The Commission has issued the enclosed Amendment Nos. *64* and *60* to Facility Operating License Nos. DPR-33 and DPR-52 for the Browns Ferry Nuclear Plant, Unit Nos. 1 and 2. These amendments are in response to your letter of September 17, 1980 (TVA BFNP TS 150).

The revised Technical Specifications allow operation of Browns Ferry Unit 2 with the standby coolant supply capability (supplied from Unit 1) inoperable for a period not to exceed ten days.

SAFETY EVALUATION BY THE OFFICE OF NUCLEAR REACTOR REGULATION  
SUPPORTING AMENDMENT NO. 64 TO FACILITY OPERATING LICENSE NO. DPR-33  
AMENDMENT NO. 60 TO FACILITY OPERATING LICENSE NO. DPR-52  
TENNESSEE VALLEY AUTHORITY  
BROWNS FERRY NUCLEAR PLANT, UNIT NOS. 1 AND 2  
DOCKET NOS. 50-259 AND 50-260

**Residual Heat Removal System, Unit  
Cross Connections and Standby Coolant Supply**

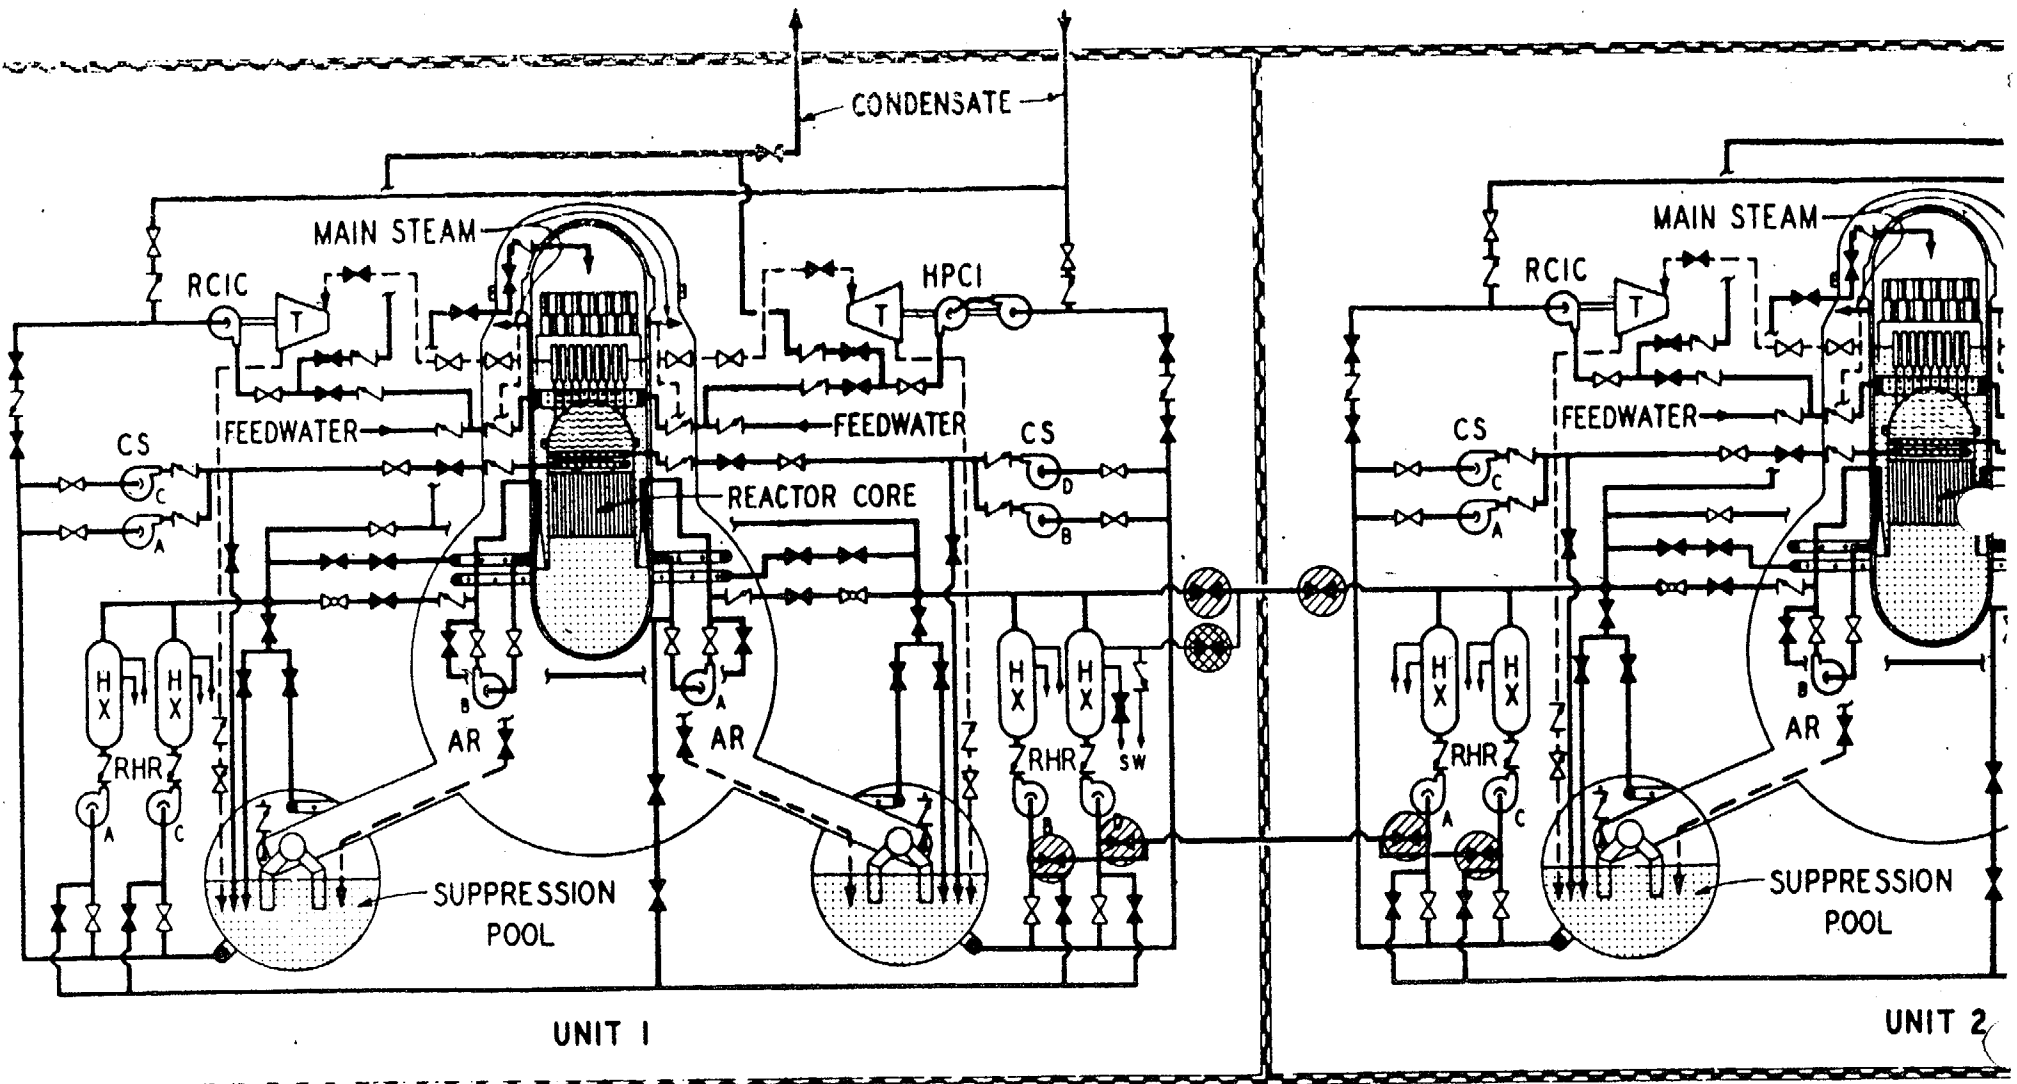
As noted in the previous safety evaluation, the RHR pump suction and heat exchanger discharge lines of one loop in Unit 1 are cross-connected to the pump suction and heat exchanger discharge lines of one RHR loop in Unit 2. Units 2 and 3 systems are cross-connected in a similar manner. This arrangement is shown in the attached figure for Units 1 and 2. The cross-connection valves are those in the lined or cross-hatched circles. The cross-hatched valve permits RHRSW (river water) from the IDRHR heat exchanger to be added to the RHR system (primary coolant) as a last-ditch emergency if all the "clean" water sources of cooling water in Units 1 and 2 have been lost (condensate, suppression pool, etc.) and the normal service water makeup in the unit in trouble is not available. The present Technical Specifications do not provide any period of time for the RHRSW cross-connection to be out of service, which in turn does not allow the associated RHR heat exchangers and RHRSW pumps to be out of service for maintenance - even though there is considerable redundancy in the RHR systems and the present Technical Specifications permit the RHR cross-flow connections to be out-of-service for up to 10 days. We conclude, as we did in Amendment No. 34, that the proposed Technical Specification change to allow a 10 day outage time for the RHRSW cross-flow connection between units is acceptable and that the overall reduction in plant safety margin is insignificant.
